To: File, Taunton WWTP, NPDES No. MA0100897

From: Susan Murphy, Permit Writer

Re: July 22, 2014 Supplemental Comments submitted by John Hall

Figure 22. Volume coverage as a function of temperature over the 1999 yearly simulation for various Brayton Point Station heat loads: MOA II (current operating condition), EMM (reduced heat operating condition), and no-plant operating scenarios.

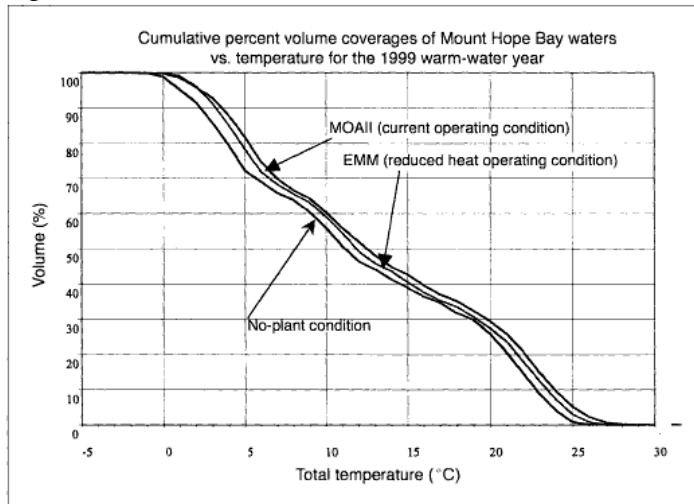
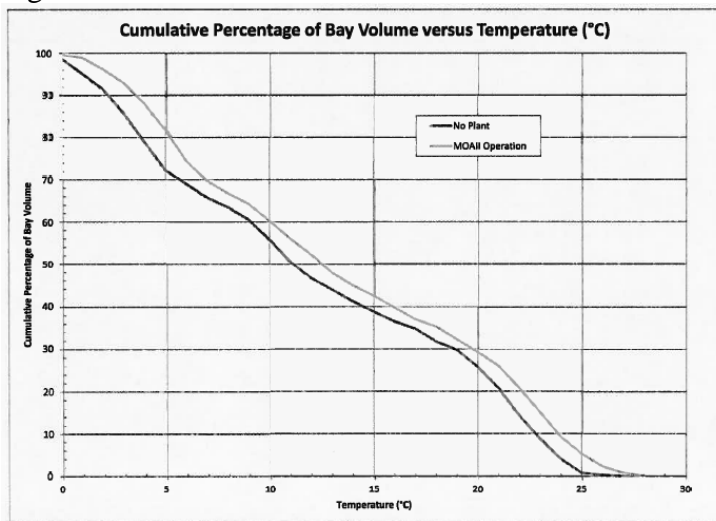
The temperature impacts noted in the 2015 memo from Swanson are the same as those presented in this 2006 article, see comparison of charts below. The one from the article shows 2 operating conditions and starts at -5° C but is substantively the same as the one we just got:

Figure 19. Plan view of daily mean water-column temperature for no-Plant hydrothermal model run on August 1, 1999.

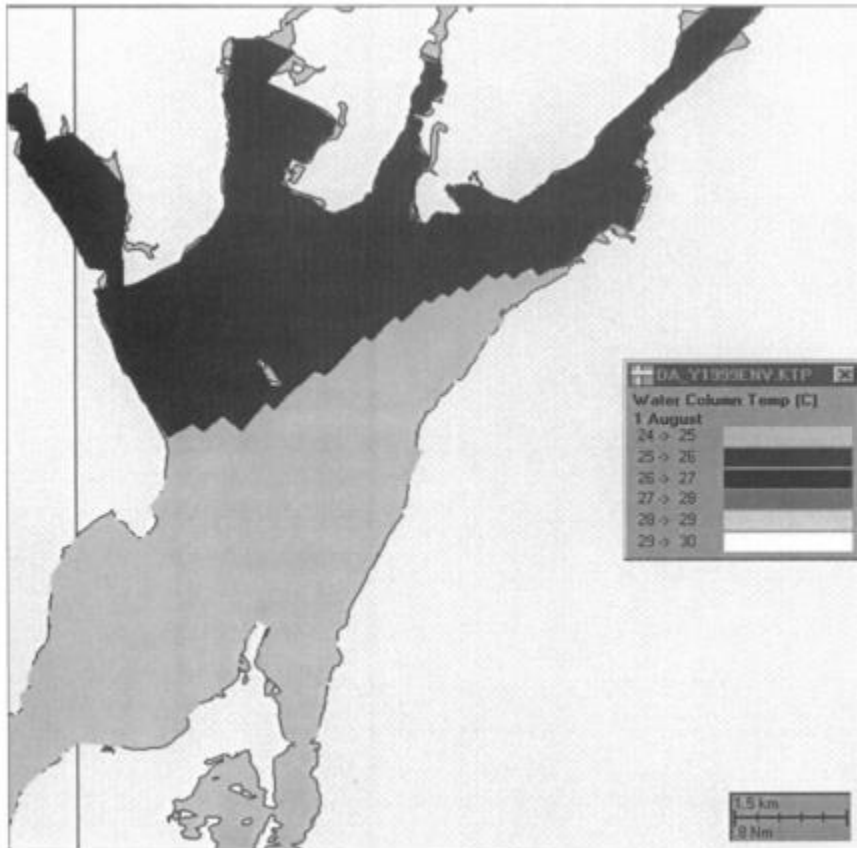
8. The thermal plume did not affect Taunton River temperatures. Swanson, 2006 at 153. Taunton River naturally has warmer temperatures than lower Mount Hope Bay. Swanson, 2006, Figure 19. Temperatures in the lower Bay with the thermal plume were actually similar to natural temperatures in the Taunton River. See Swanson, 2006, Figures 15 and 17. So the thermal conditions in 2004-06 actually made lower Mount Hope Bay more comparable to the Taunton River and the thermal studies do not indicate need to correct for impacts of eliminating the thermal plume if any could be shown.

Figure 15. Plan view of daily mean water-column temperature for MOA II hydrothermal model run on August 1, 1999.

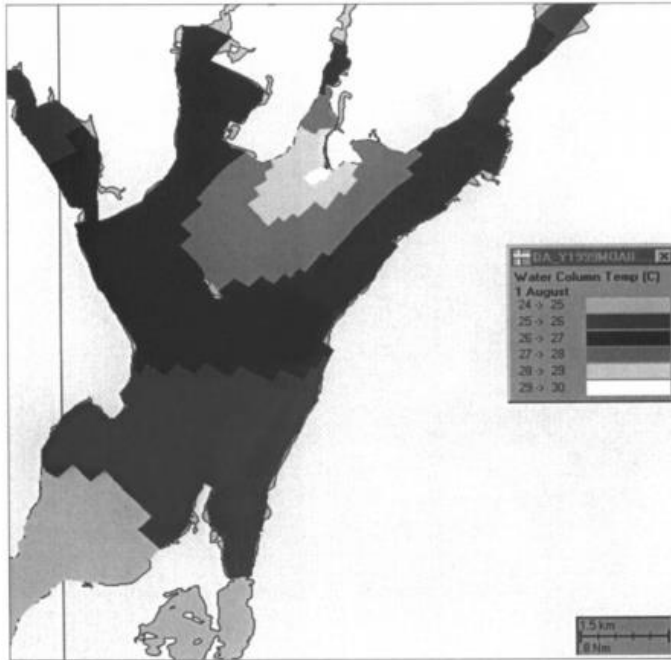
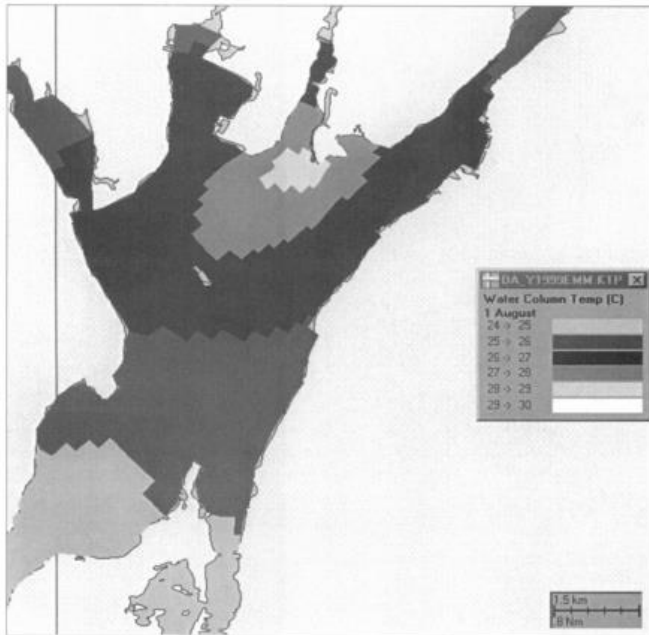
7. Also, the temperature impact from eliminating the thermal plume is less in the lower reaches of Mount Hope Bay (our reference area) than the bay average, Swanson 2006, Figures 15 and 17, and eliminating the thermal plume has no temperature impact in the Taunton River. See Swanson, 2006 at 153. Again this means that any related change in DO saturation is much lower than suggested in the memo.

Figure 20. Plan view of surface temperature differences for the EMM hydrothermal model run relative to the no-plant run at maximum ebb. Vertical cross-sectional view from the outfall is seen in the insert.

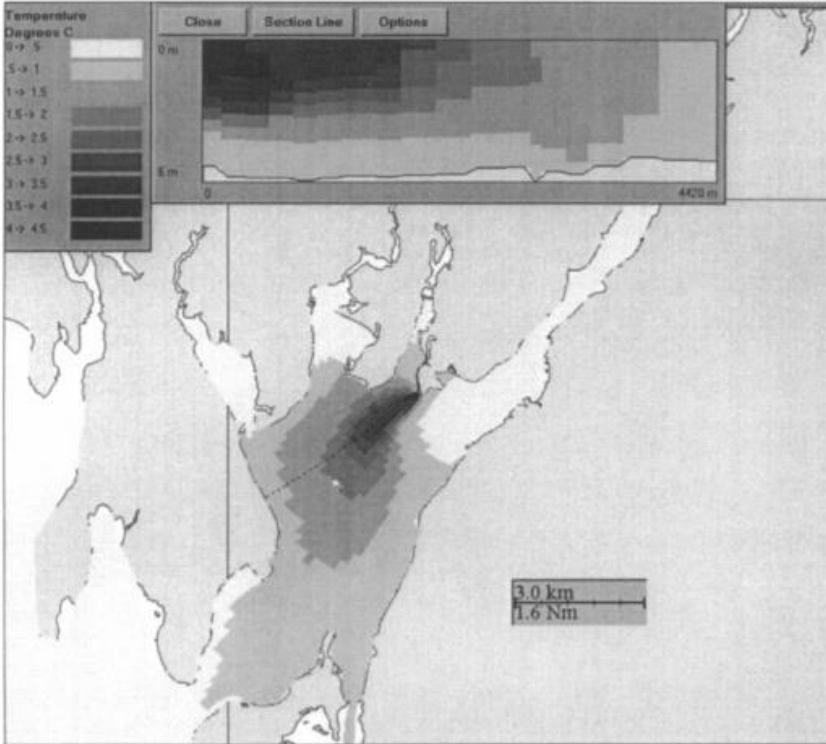
6. The temperature impact from eliminating the thermal plume is much less in bottom waters than the bay average (based on plume cross-sections in Swanson, 2006, Figures 20 and 21) so actual temperature difference (and related change in DO saturation) in the bottom waters where critical DO conditions exist is much less than suggested in the memo.
